Technical Bulletin L70

Product: DVD Receiver

Hardware Technical Bulletin: H2004-03

Subject: SCART RGB OUTPUT

Figure1

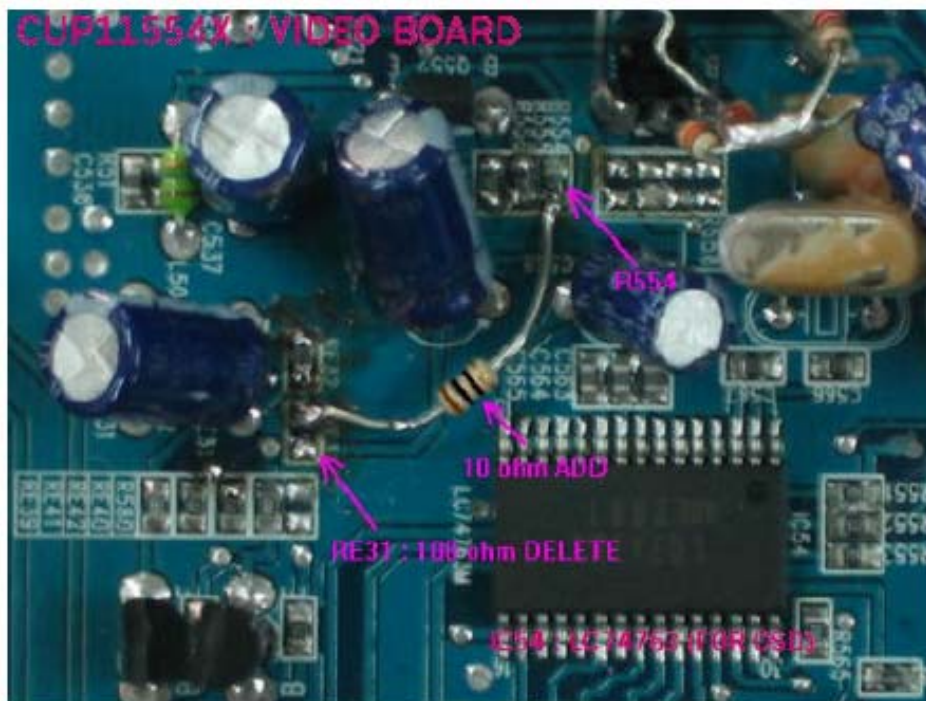
DESCRIPTION: You may have the complaint that the Scart RGB output is not switching automatically.

REASON: The drive current required for some TV sets is greater then the L70 can supply to switch the RGB output.

SOLUTION: Delete RE31 100 ohm resistor on the video board. Add a 10 ohm resistor between pin 16 of SCART connector (one leg of RE31) and +5v rail (one leg of R554) on video board. See Figure 1 and Figure 2.
